Norfolk Vanguard Offshore Wind Farm

Statement of Common Ground

Natural England

Applicant: Norfolk Vanguard Limited
Document Reference: Rep2 - SOCG - 13.1
Revision: 2

Figure 2.1 *Sabellaria spinulosa* reef mapping by the Applicant and Natural England

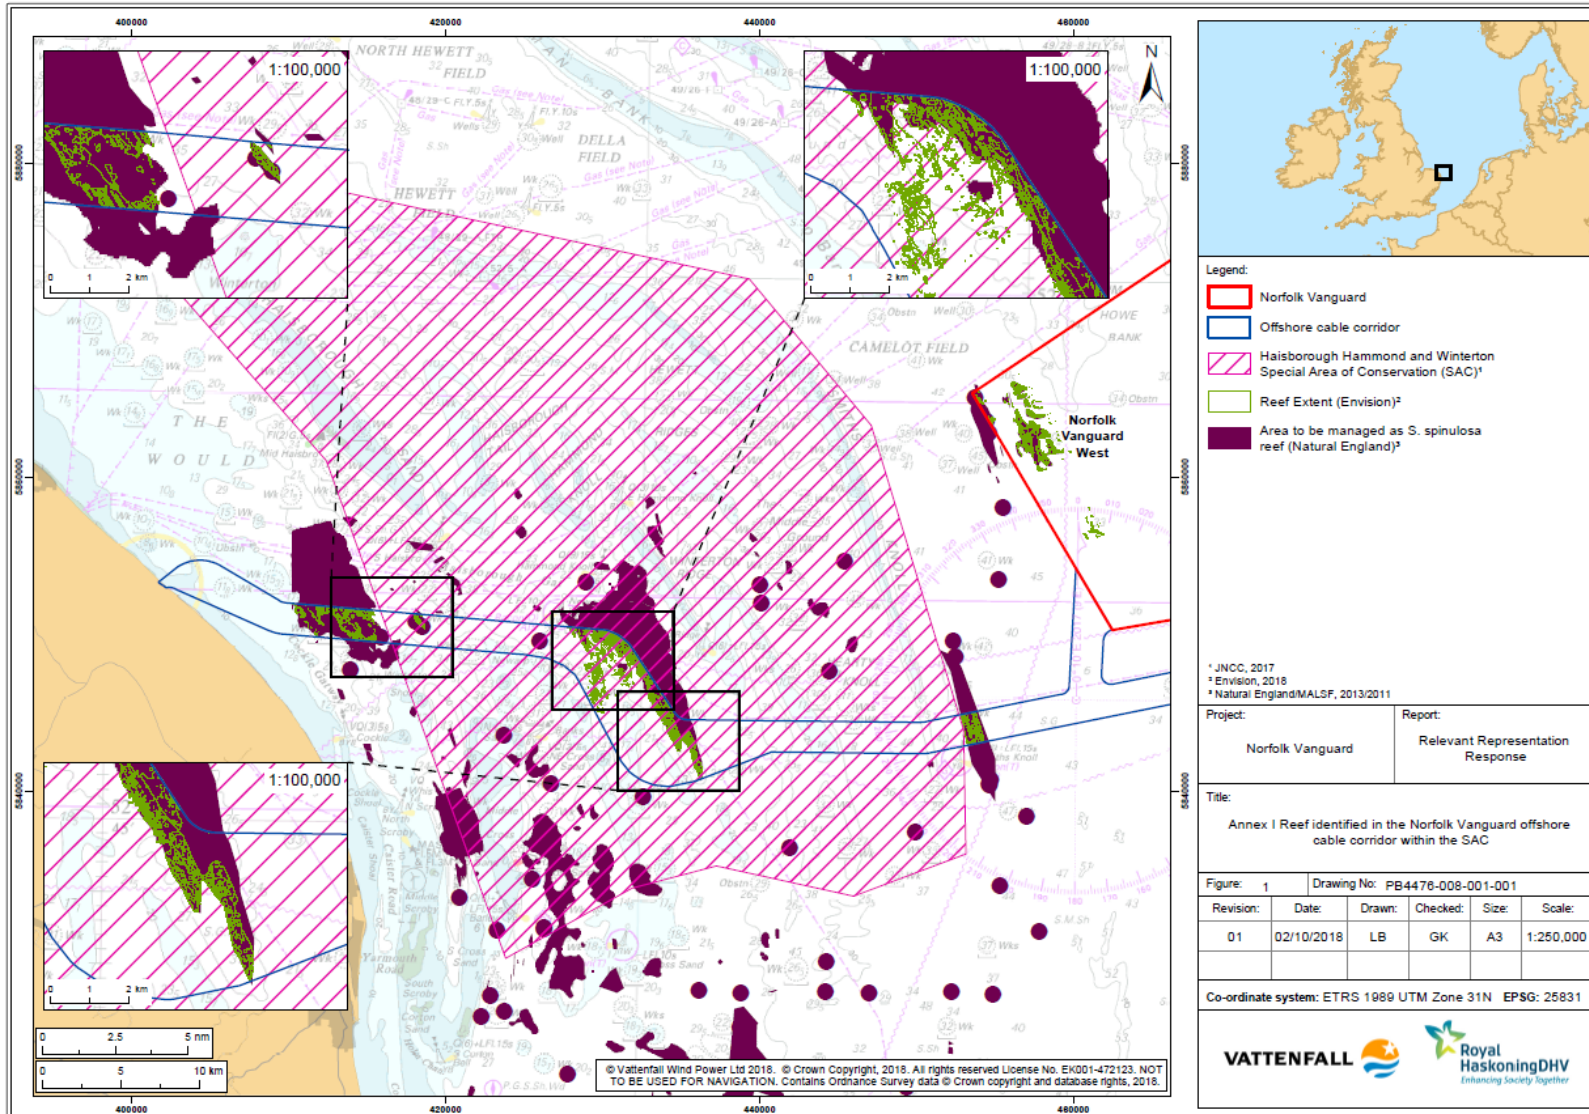
| Topic | Norfolk Vanguard Limited position | Natural England position | Final position |
|------------------------|--|---|---|
| | The mapping of potential <i>S. spinulosa</i> reef by Envision on behalf of Norfolk Vanguard Limited identifies potential reef areas which are largely consistent with areas Natural England has identified (as shown on Figure 2.1 below). | Agreed | It is agreed by both parties that the mapping of potential <i>S. spinulosa</i> reef by Envision on behalf of Norfolk Vanguard Limited identifies potential reef areas which are largely consistent with areas Natural England has identified. |
